Subject: FEBEG comments on ELIA's public consultation on amendment of the T&C BSP aFRR
Date: 18 January 2022

FEBEG thanks ELIA for having the opportunity to react ELIA's public consultation on the proposal for amendment of the T&C BSP aFRR¹.
The inputs and suggestions of FEBEG are not confidential.

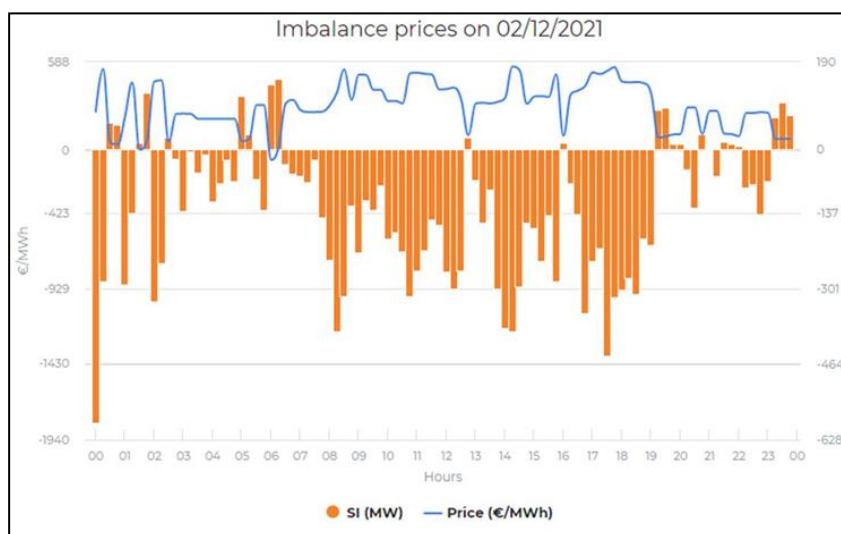
The proposed definition of the Limited Energy Reservoir seems not consistent with the definition of the term used in the T&C of FCR:

- For aFRR a LER is any Delivery Point with a Technical Unit which is unable to continuously supply one direction for 4 hours (one CCTU) when starting from a 50% filled energy reservoir.
- For FCR this is any delivery point that could face an exhaustion of its energy reservoir within the time frame contracted by ELIA and taking into account the effective energy reservoir level available at the beginning of that timeframe.

To FEBEG the reasoning behind the aFRR LER definition is unclear.
